Re: Submission to MOD 2018/0294

**Proposed Modification to DA367/2010**

46 Victoria Parade, Manly

Figure 5: Unit locations (source: Urbaine Architecture, shadow diagrams)

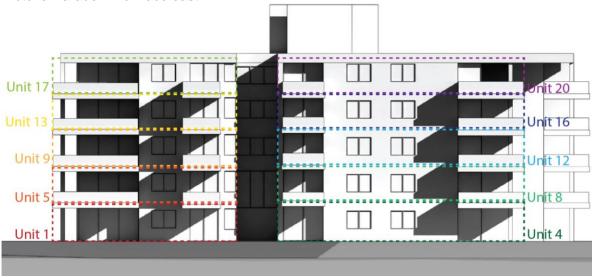
Nonetheless, the new shadow diagrams clearly demonstrate additional overshadowing as a result of the roof amendments. In particular units 16, 13, 12, 9, 5 and 1 are further overshadowed by the proposed roof.

Unit 16 (level 3, front) will be further overshadowed at 9am and 10am. The amended roof will result in overshadowing of the large glass balcony doors which face east at 9am. This will result in a loss of sunlight to the main living area which currently receives a significant amount of sunlight from these glass doors. In addition, at 10am the new roof form will additionally overshadow the kitchen window and bedroom balcony and doors. These windows and doors are overshadowed by the approved development at 9am.

Unit 13 (level 3, rear) is also impacted by the additional overshadowing from the amended roof. The new roof will now generate overshadowing at 10am. Sunlight to this unit will be significantly reduced as the unit is currently overshadowed at 9am, while at 11am and 12pm the building begins to overshadow the balcony and the kitchen and bedroom windows. The amended roof therefore removes all sunlight access to this unit where previously a small amount of sunlight was provided at 10am.

Unit 12 (level 2, front) is impacted by the new roof from overshadowing to the bedroom balcony and bedroom window. The new roof will result in additional overshadowing at 11am, where currently significant solar access is provided. Sunlight to this unit will be significantly reduced as the unit is currently overshadowed at 9am and 10am, while at 12pm onwards the building begins to overshadow the balcony. The amended roof therefore removes sunlight access to this unit's bedroom balcony where previously a small amount of sunlight was provided at 11am.

Unit 9 (level 2, rear) is also significantly impacted by the proposed roof form. Under the approved scheme this unit only receives sunlight at 11am. Before 11am the unit is overshadowed by the approved building and after 11am the building overshadows itself. The new roof proposes to remove almost all solar access to this units windows and balconies.

Unit 5 (level 1, rear) has limited sunlight access currently, where sunlight would be provided between 11am to 12pm for less than an hour. The additional overshadowing from the modified roof would however remove this small amount of sunlight, especially to the bedroom balcony. Due to the already limited amount of sunlight available to this unit, the small reduction will have a significant impact resulting in an almost total loss of sunlight.

Unit 1 (Ground level, rear) has very limited sunlight access, with a small amount of sunlight being provided at 1pm to the courtyard. The additional overshadowing from the modified roof would remove this small amount of sunlight as the additional roof form will likely result in further shadow to the ground floor courtyard. Plan shadow diagrams have not been provided which would likely demonstrate this. Due to the already limited amount of sunlight available to this unit, the small reduction will have a significant impact resulting in a total loss of sunlight.

As a result of this overshadowing, it is recommended the original roof be retained. There has been no justification by the Applicant as to why a flat roof is required, in addition, there has been no justification as to why the overshadowing impacts resultant of the new roof form are acceptable.
